Pin Assignment Changes - CANbus and Mosfets

**Changes to pin assignments with WatchMon 4.3, WatchMonPlus 5.2 and WatchMonPlus 7.1.**

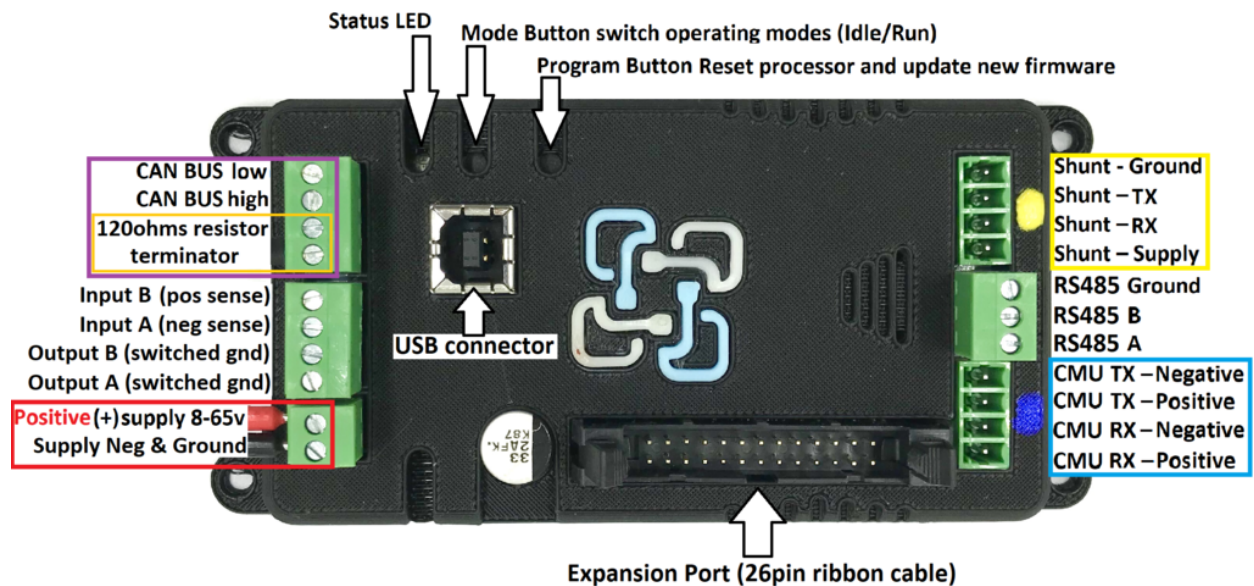
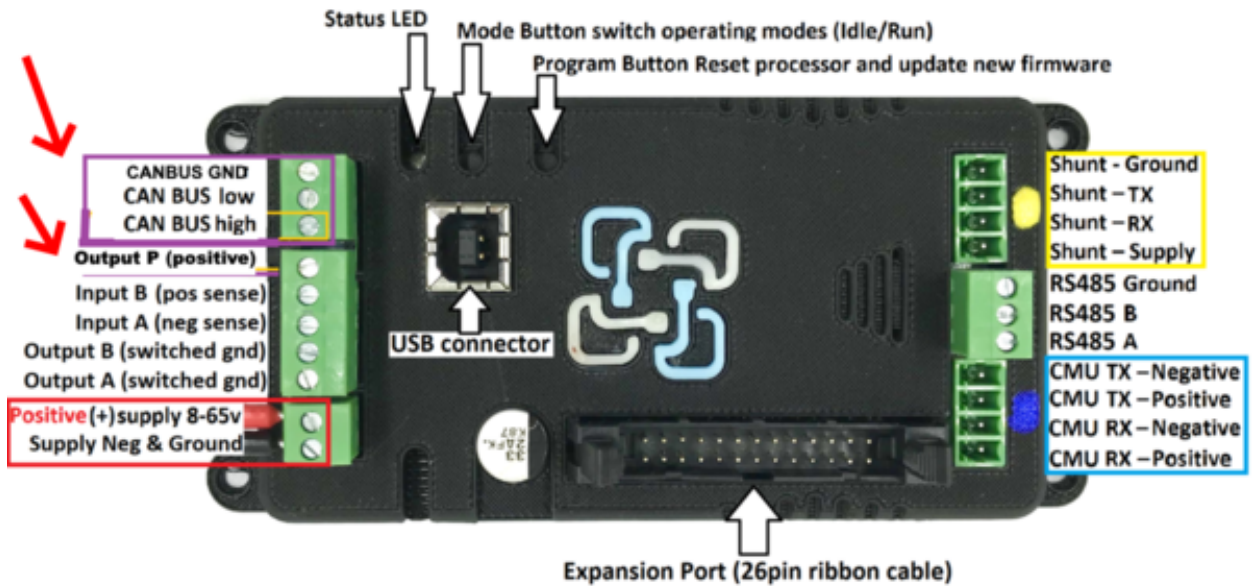
- CANbus has changed from a 4 pin to a 3 pin plug
- Mosfet outputs changed from a 4 pin to a 5 pin plug adding an Output P (positive)

WatchMon4 pin assignment

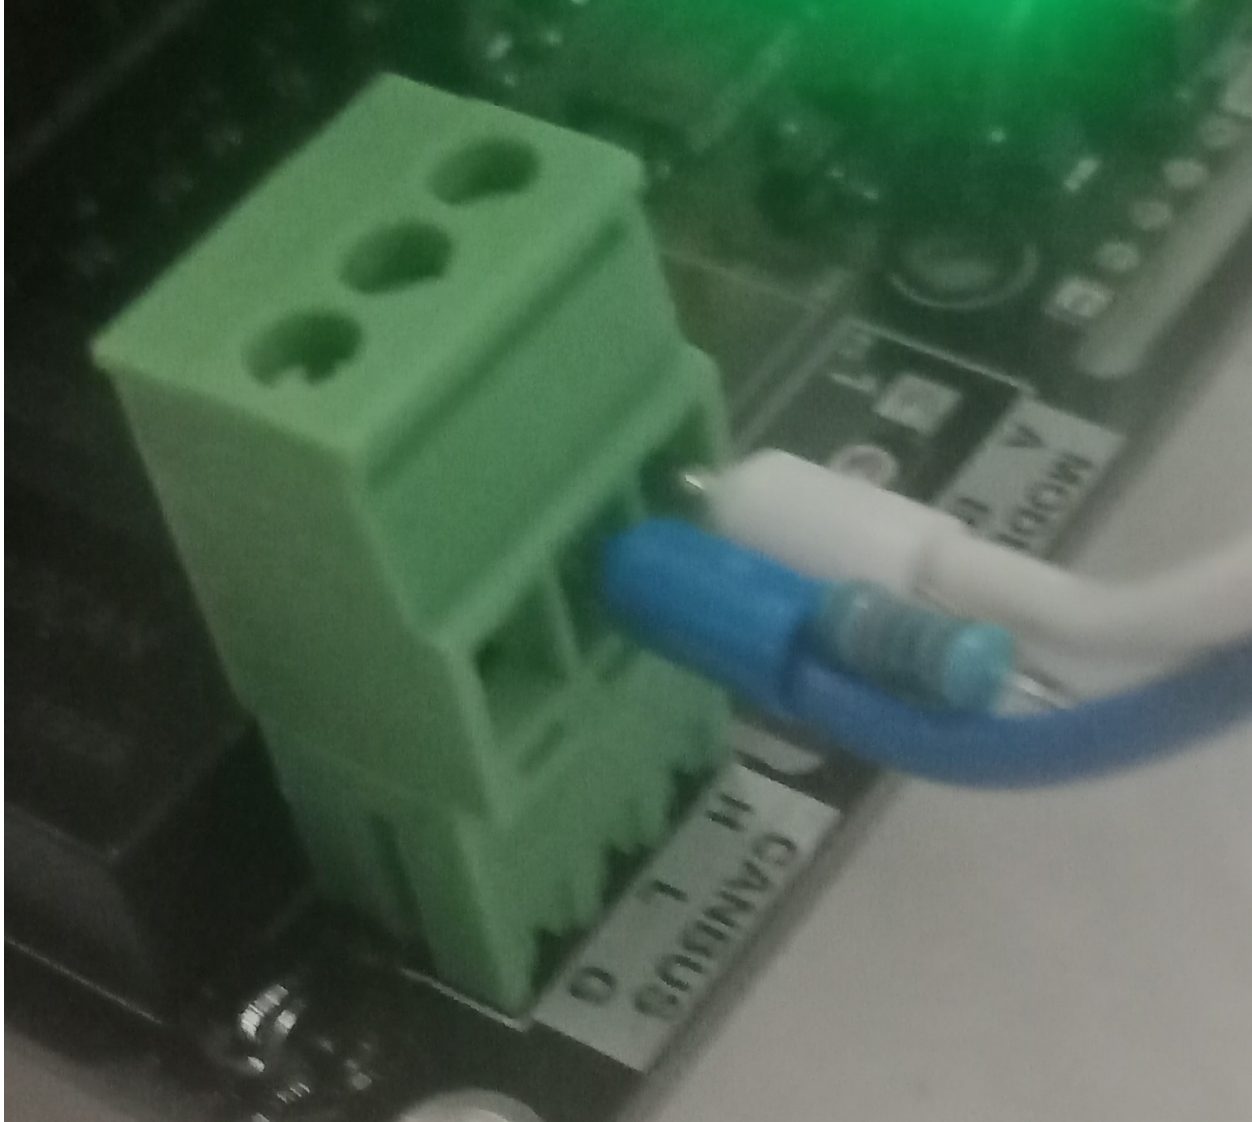
Canbus Has Changed From A 4 Pin To A 3 Pin Plug

- CANbus ground was added as a number of inverters required this and hence this broadens the range of inverters possible.
- If CANbus Ground is not needed for your inverter then it should remain unused
- the 120 Ohm resister is still required and should be put between CANbus High and Low (see below example)

Mosfet Outputs Changed From A 4 Pin To A 5 Pin Plug Adding An Output P (Positive)

We have documents for wiring fans and wiring contactors labelled either 4 pin or 5 pin explaining the changed requirements. This change makes the device more robust.
